**AGENDA**  
**MANOR PLANNING AND ZONING COMMISSION**  
**105 E. EGGLESTON ST.**  
**MANOR, TEXAS 78653**  
**AUGUST 12, 2015, 6:30 P.M.**

Re: First Construction Plan and Final Plat Review for  
Shadowglen Phase 2, Section 20 Subdivision  
City of Manor, Texas

Re: Stonewater Subdivision Phase 5  
First Final Plat Application Submittal  
City of Manor

Re: Stonewater Subdivision Phase 7  
First Final Plat Application Submittal  
City of Manor

RE: Stonewater Subdivision: Phase 2 - Final Plat Revision Submittal

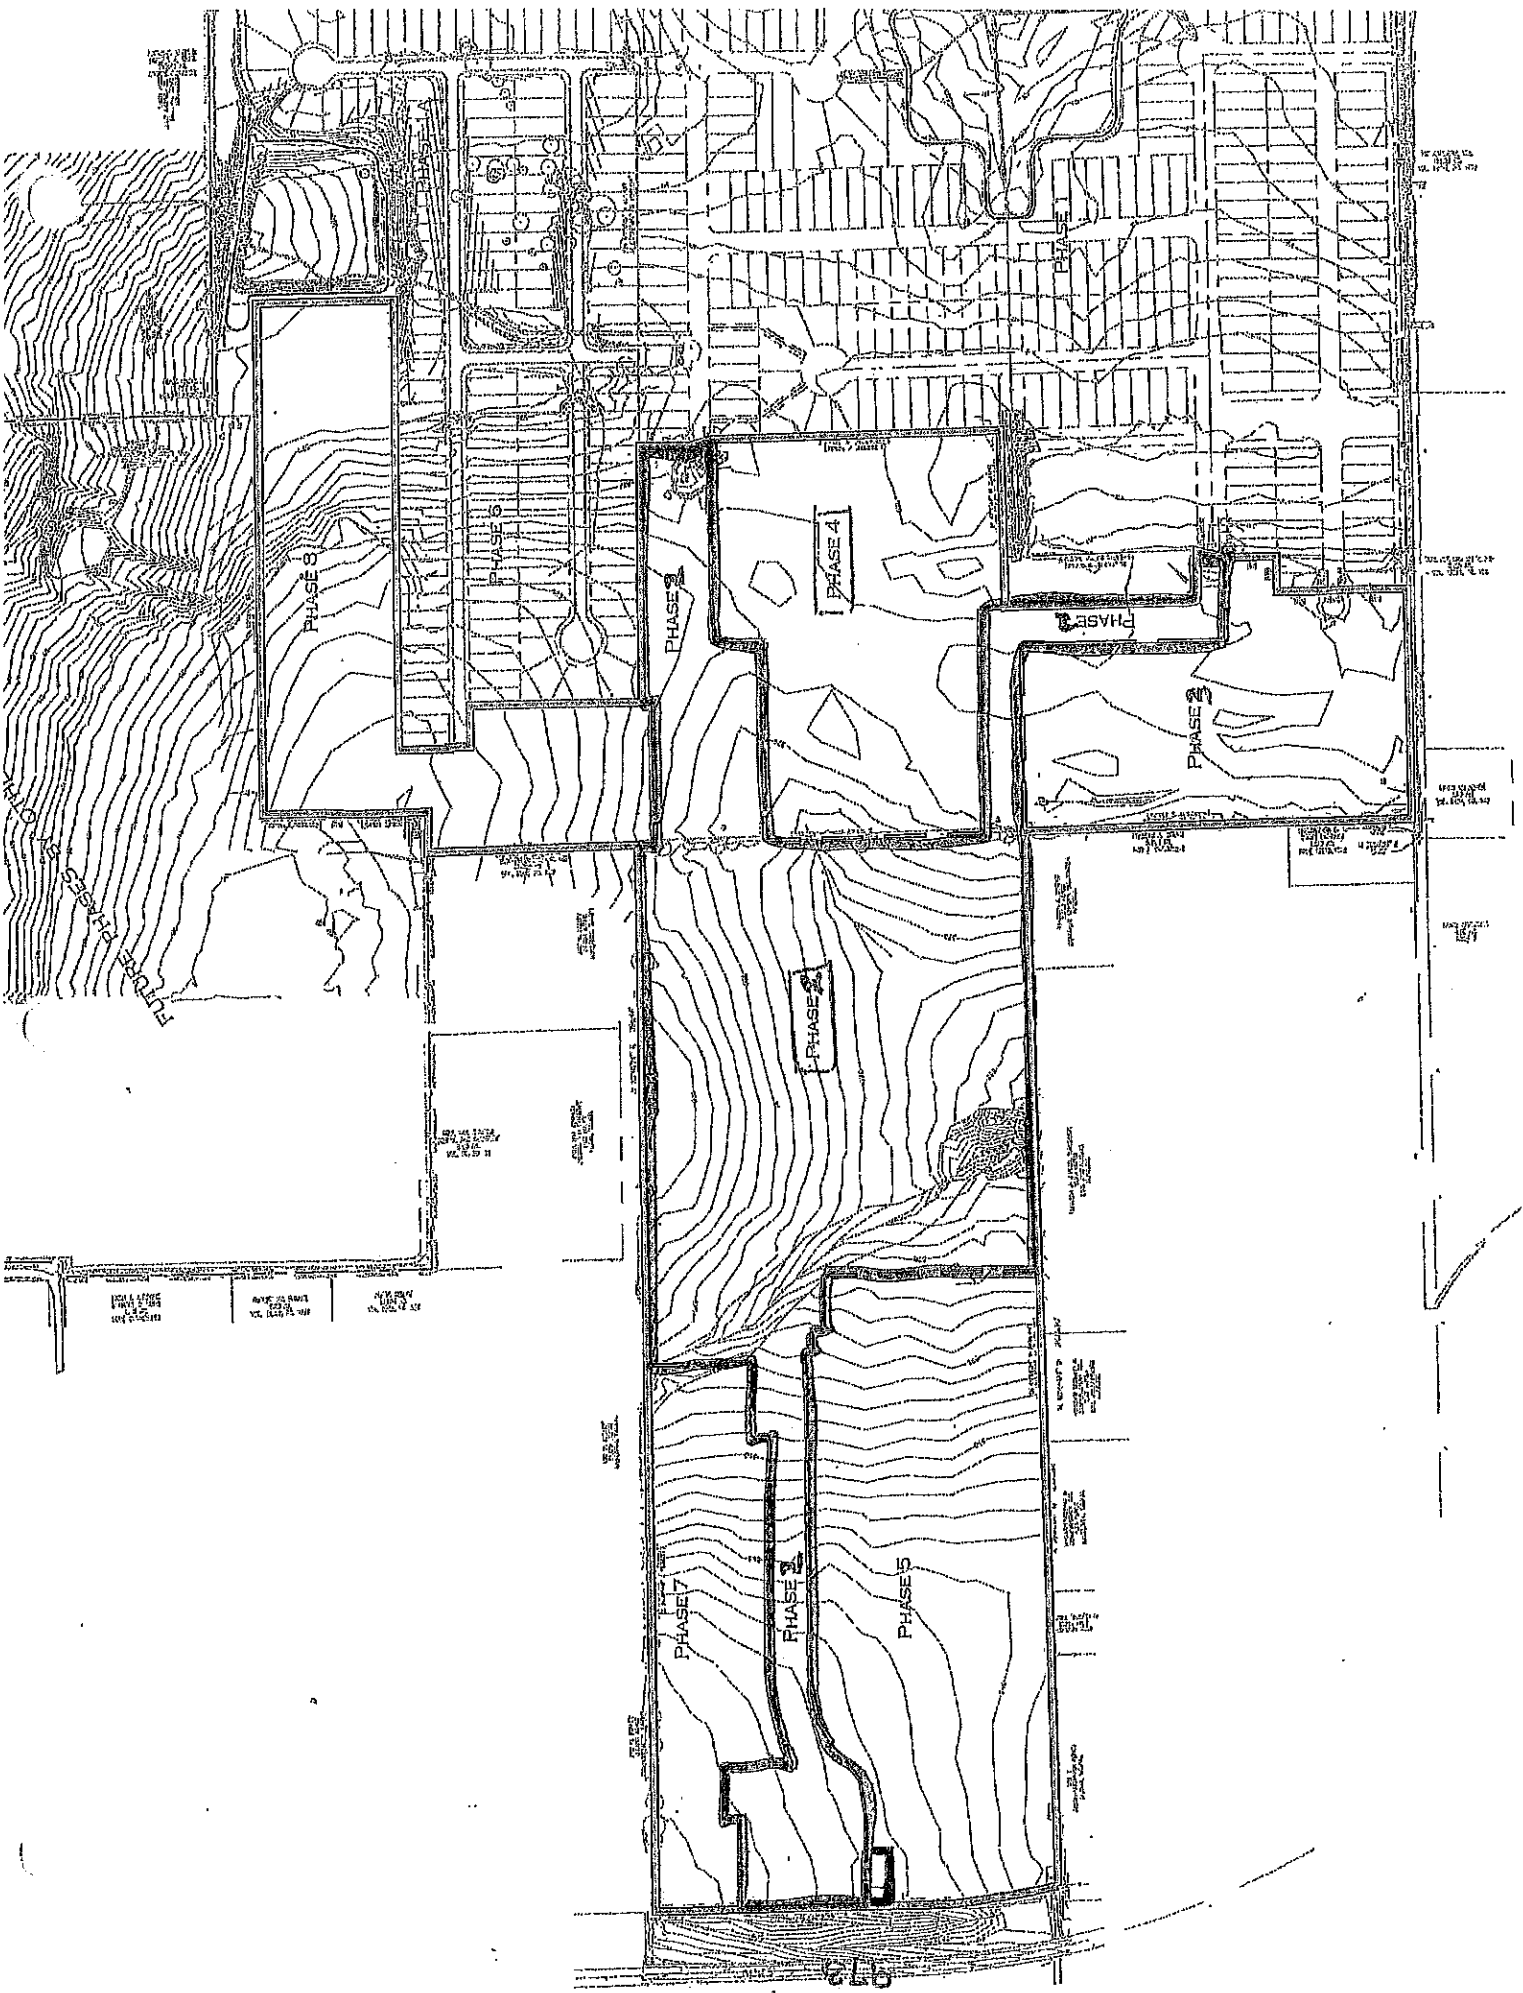
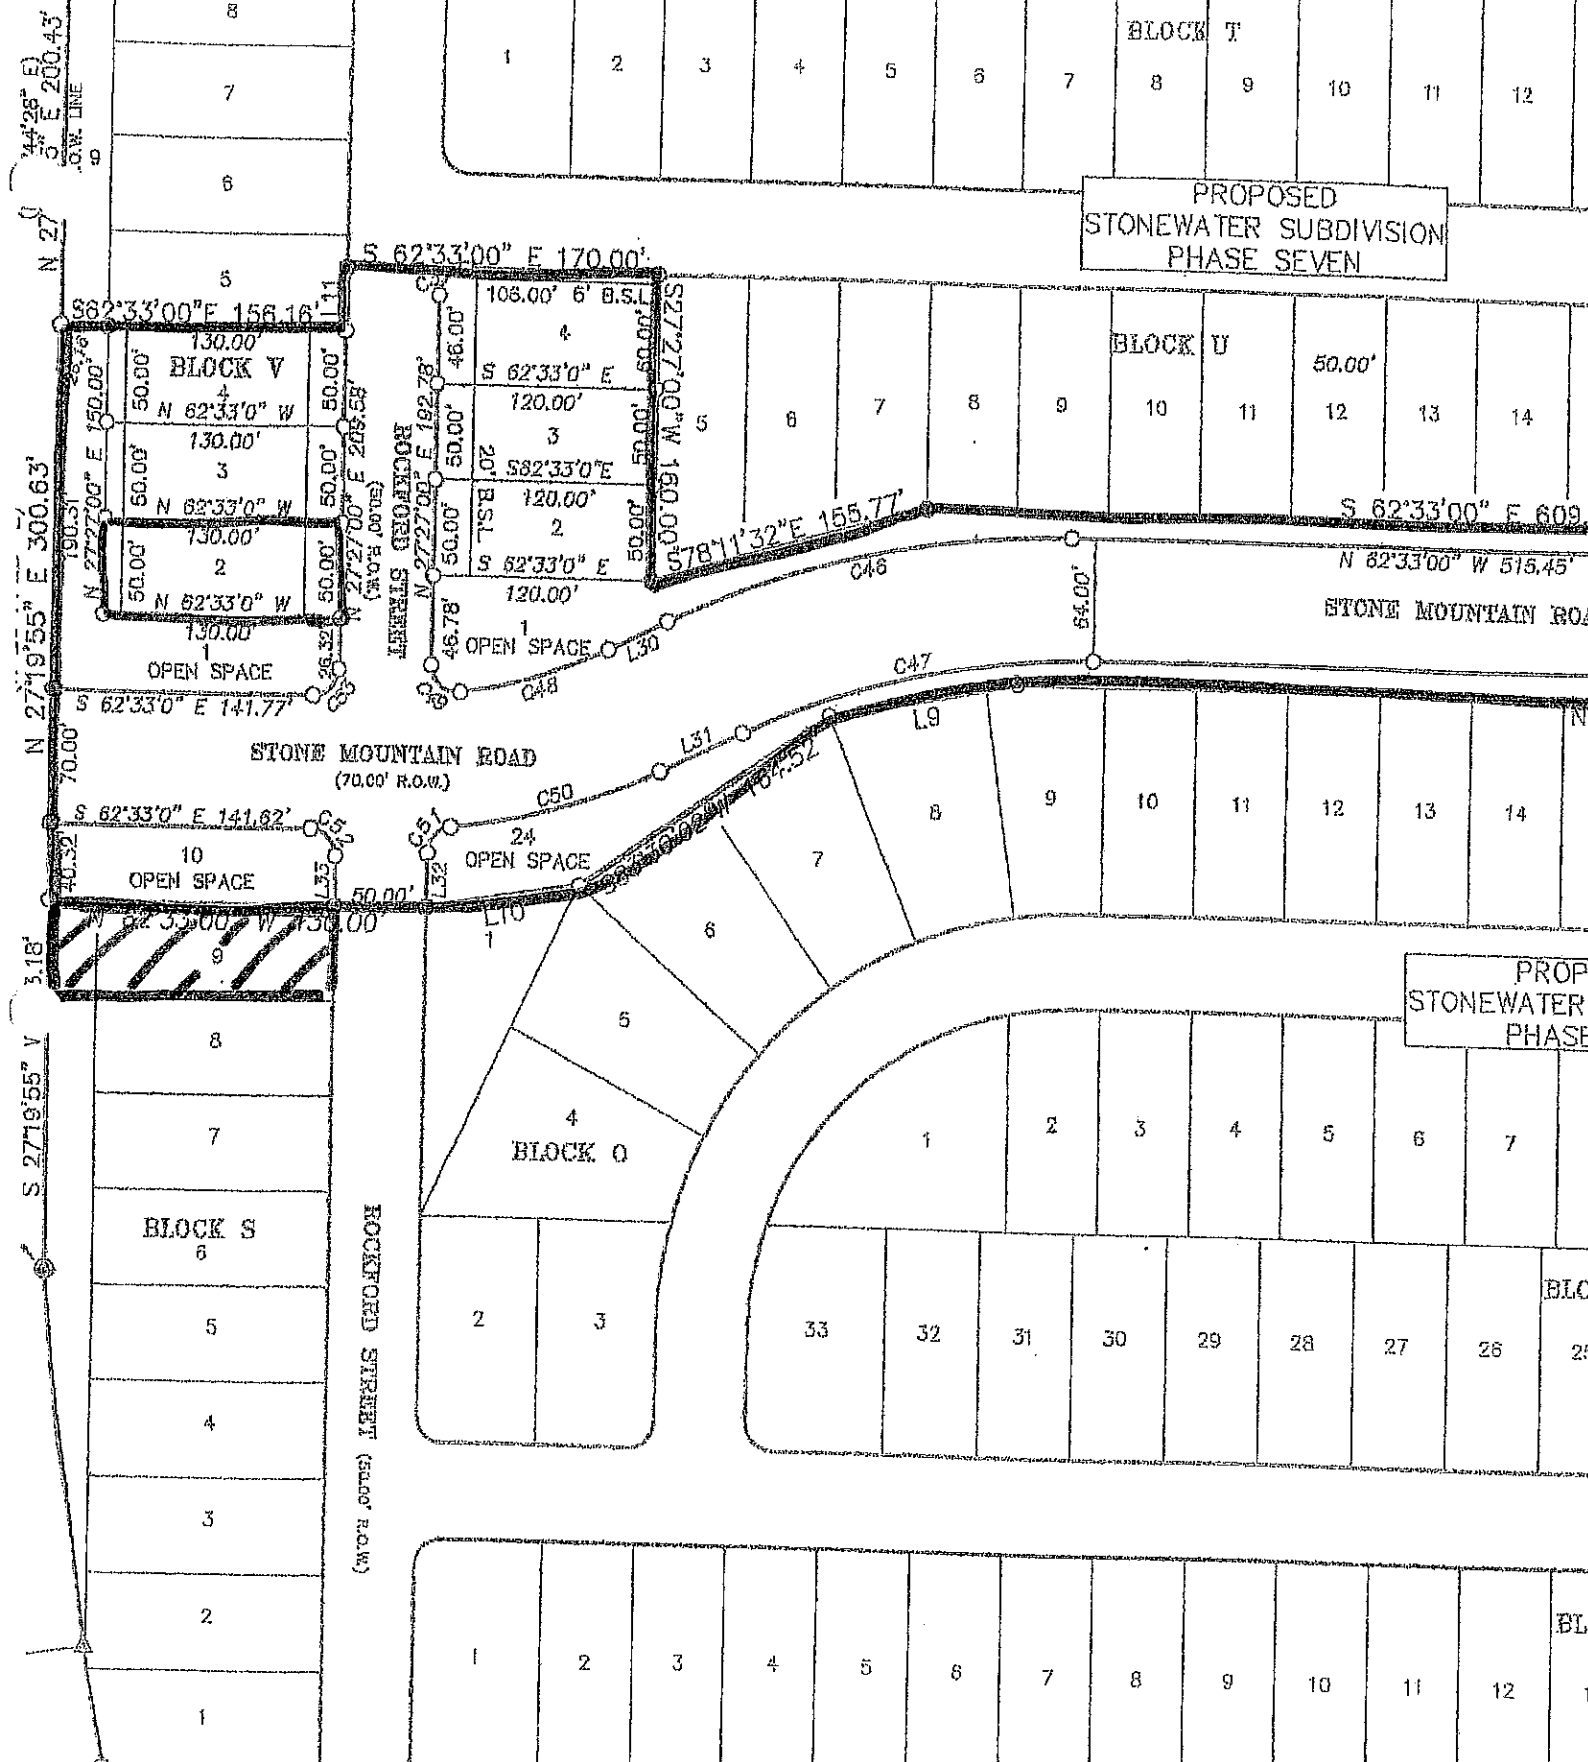
- Lot 9, Block S was previously a part of Stonewater Phase 5 but is now included in Stonewater Phase 2
- Lot 2, Block V & Lot 9, Block S were both residential lots but are now Open Space Lots.
